PLANNING BOARD AGENDA
FEBRUARY 23, 2022 – 7:00 P.M.

RE: G&F Subdivision Lots 5, 6, & 7
Gateway Drive

Since we met with the Board on February 10, 2022, we have prepared the drainage and utility profiles and added them to the site plan set. In addition, we have made the following updates to the site plans and subdivision plats in response to the following:

RE: Site Plan P&R Estate Corp.
44.13-2-68

SITE CONFORMITY PLAN

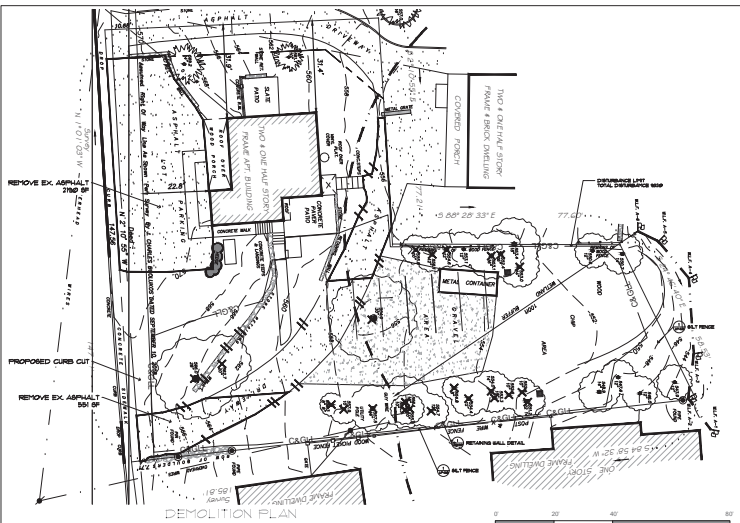
#1: The numbers on the zoning table are incorrect
Applicant has revised numbers

GRADING AND DEMOLITION PLAN
 P&R Estate Corp.
 122 Glenside
 Carmel NY

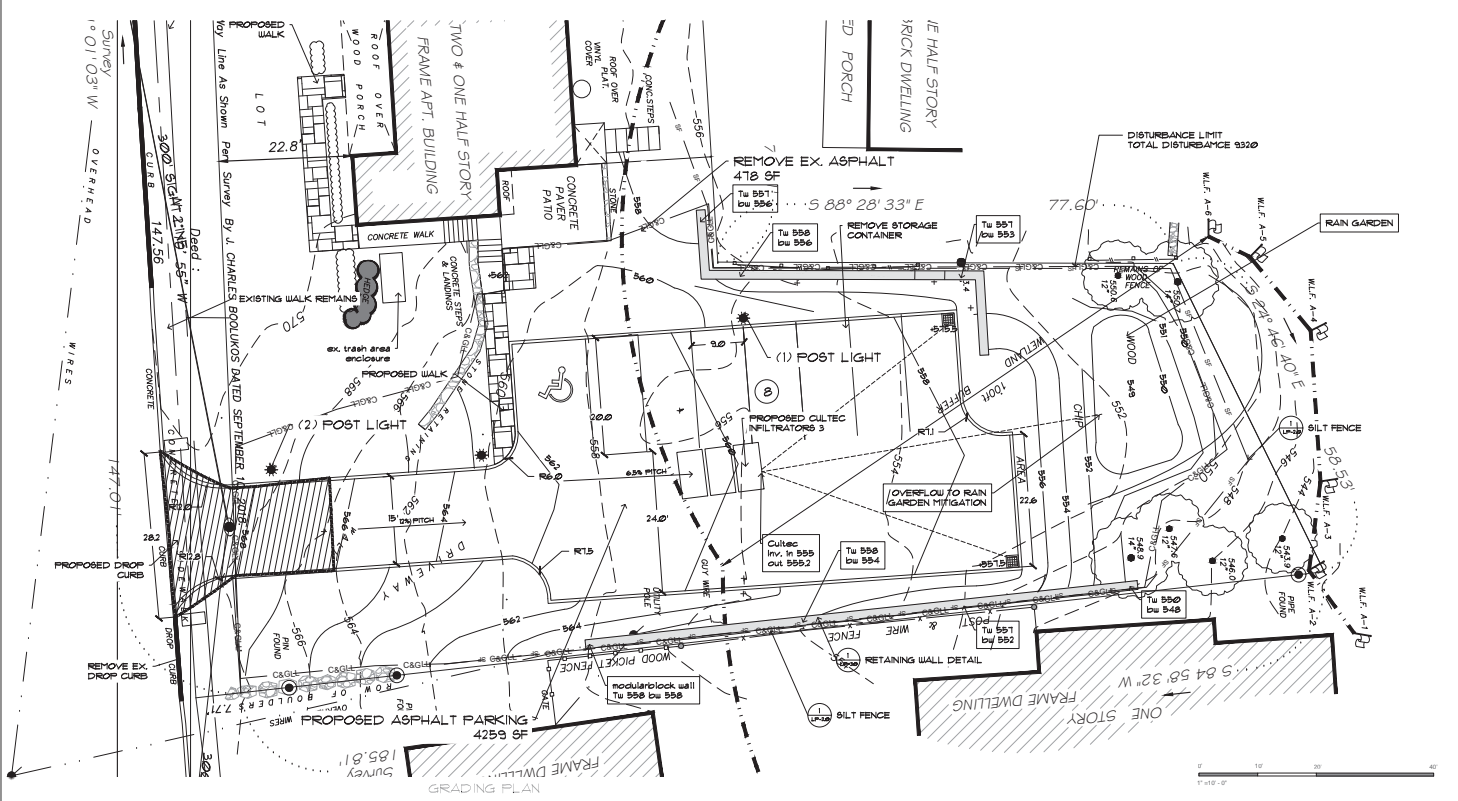
#8 available site distances and calculations should be specified on plan..

Applicant has shown site distances on the plan, applicant is utilizing the approximate location of an existing curb cut as well. applicant will make improvements as necessary. Sight distance needed is 300 If for the posted speed limit.

LAYOUT & LANDSCAPE PLAN

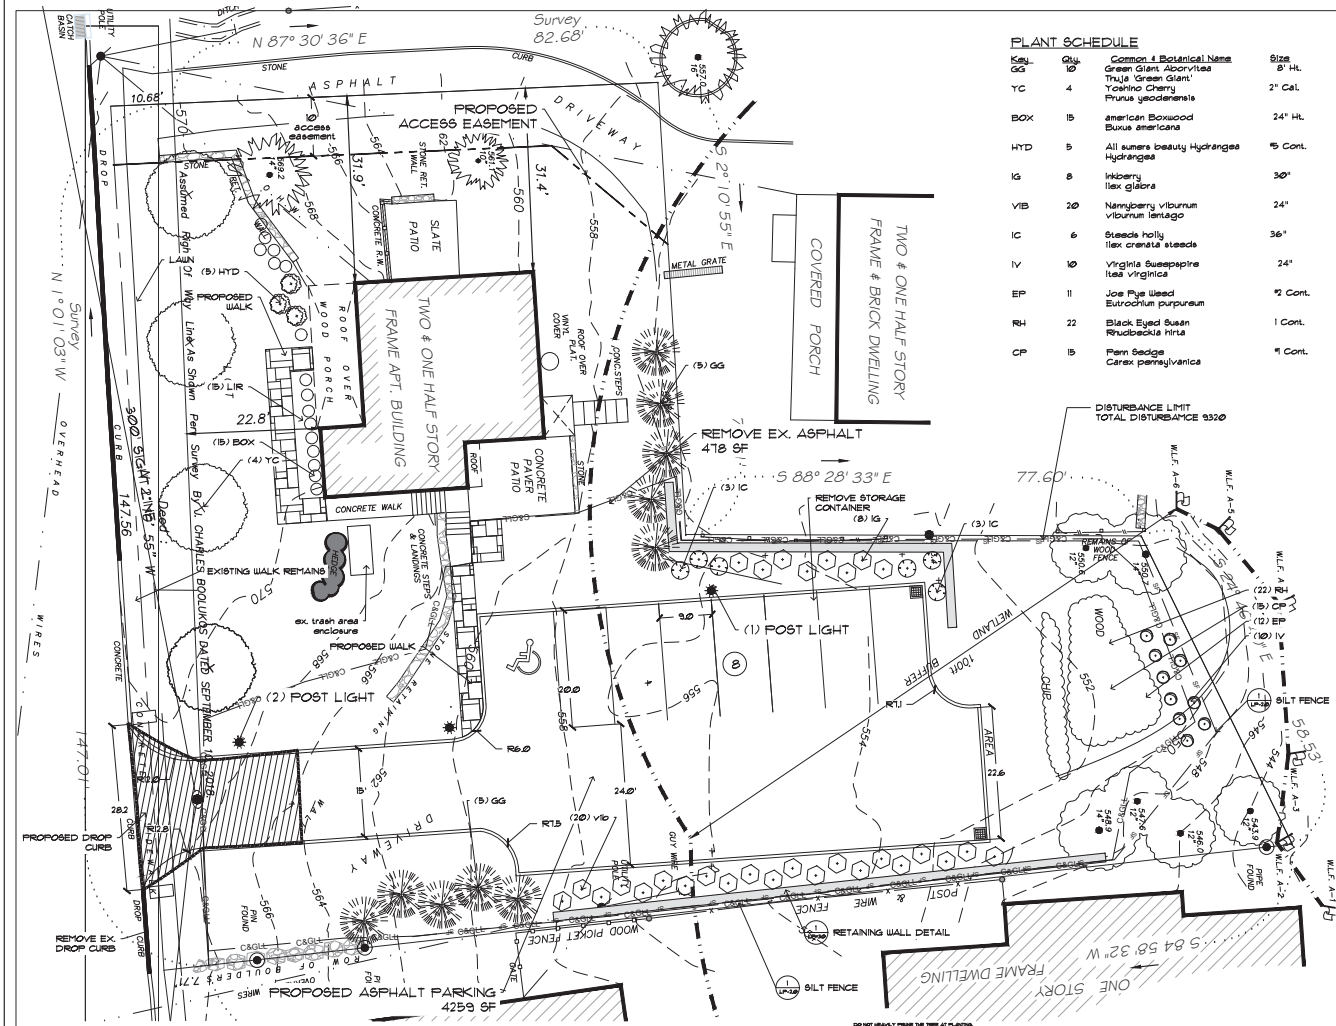
#3: The 4 dwelling units requires the provision of 8 off street parking spaces..
Applicant has updated the plan, designing the property so as all the parking is now off the street and contained in a paved uniform parking area.
